# Camden Local Planning Panel

## Agenda

**21 September 2021**

**SUBJECT: DA/2020/232/1 - ALTERATIONS AND ADDITIONS TO AN EXISTING HERITAGE BUILDING (GLEDSTOOD HOMESTEAD) AND A CHANGE OF USE TO A CENTRE-BASED CHILD CARE FACILITY FOR 80 CHILDREN AND ASSOCIATED SITE WORKS AT 900A CAMDEN VALLEY WAY, GLEDSTOOD HILLS**

Figure 4: Site plan extract demonstrating the extent of the IN2 Light Industrial zone with a blue dashed line and the 50m beyond in red dashed line (being the extent of the encroachment into the RU1 Primary Production zone).

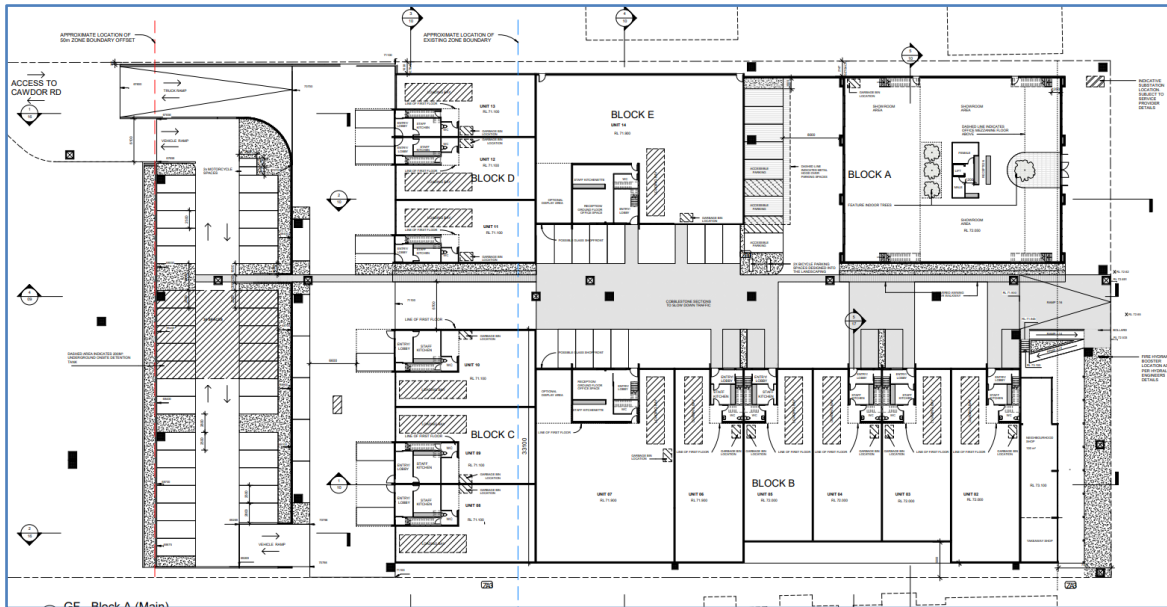
The proposal relies on Clause 5.3 Development Near Zone Boundaries for the extent of the development that encroaches into the RU1 Primary Production zone.

Figure 6: Plan extract showing potential link between take-away shop and neighbourhood shop.

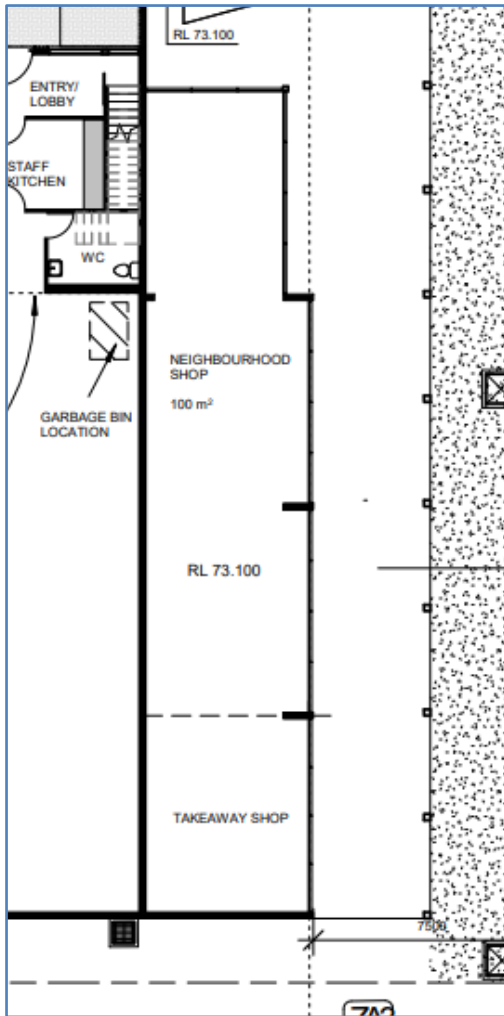
As no details have been provided for the fit-out and use of either of these tenancies concerns are raised that the uses will operate as a single shop resulting in a non-compliance. Should the application be approved a solid wall should be required as a condition of consent to separate the two uses and ensure a compliant outcome.

Figure 8: Showing solar access impacts. Existing development shown purple, proposed shown grey with yellow hatching.

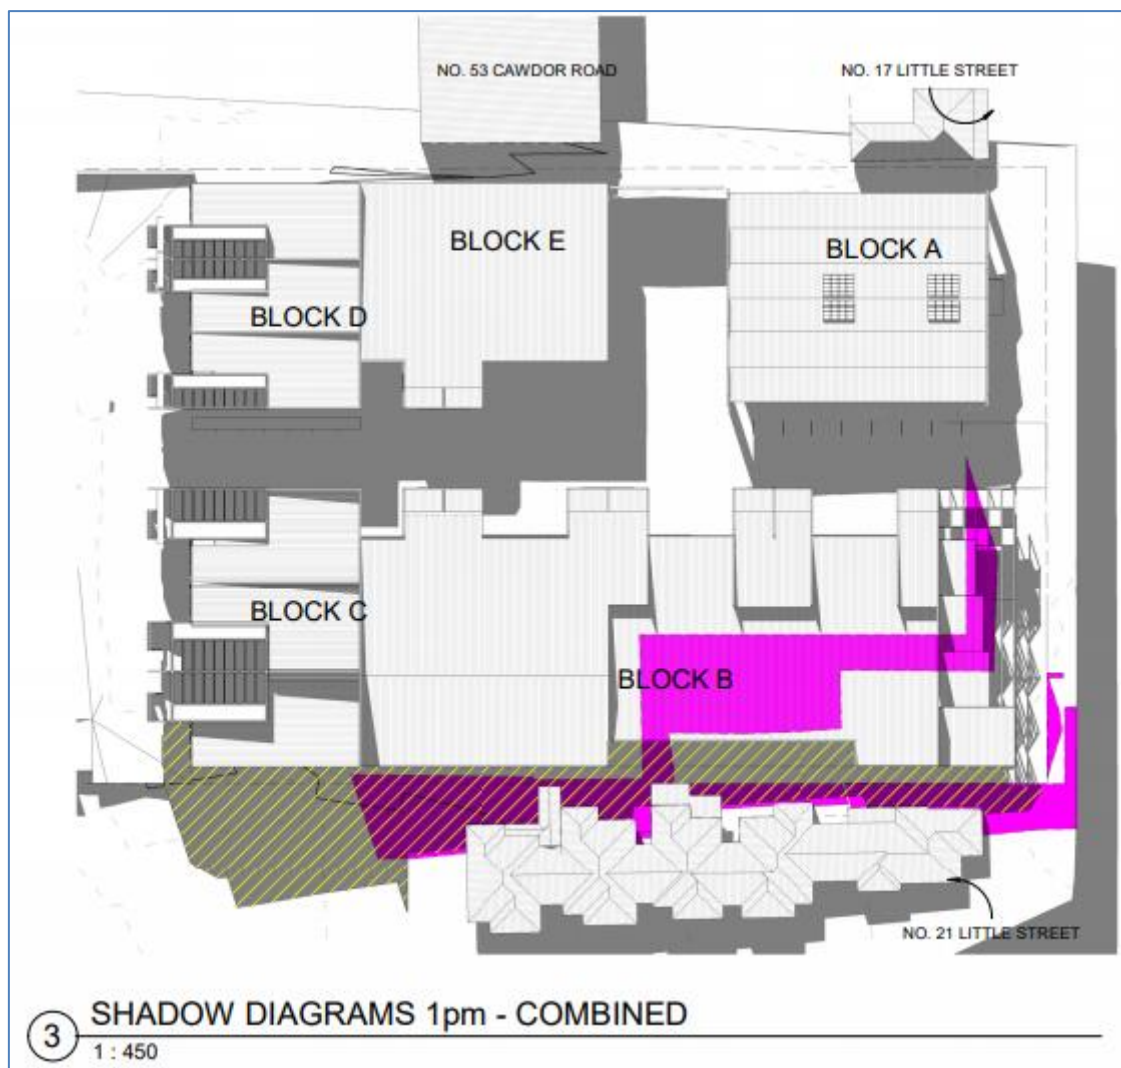
It is noted that the existing shadows cast appear to show shadows cast from the boundary fencing, which is not appropriate for considering solar access.
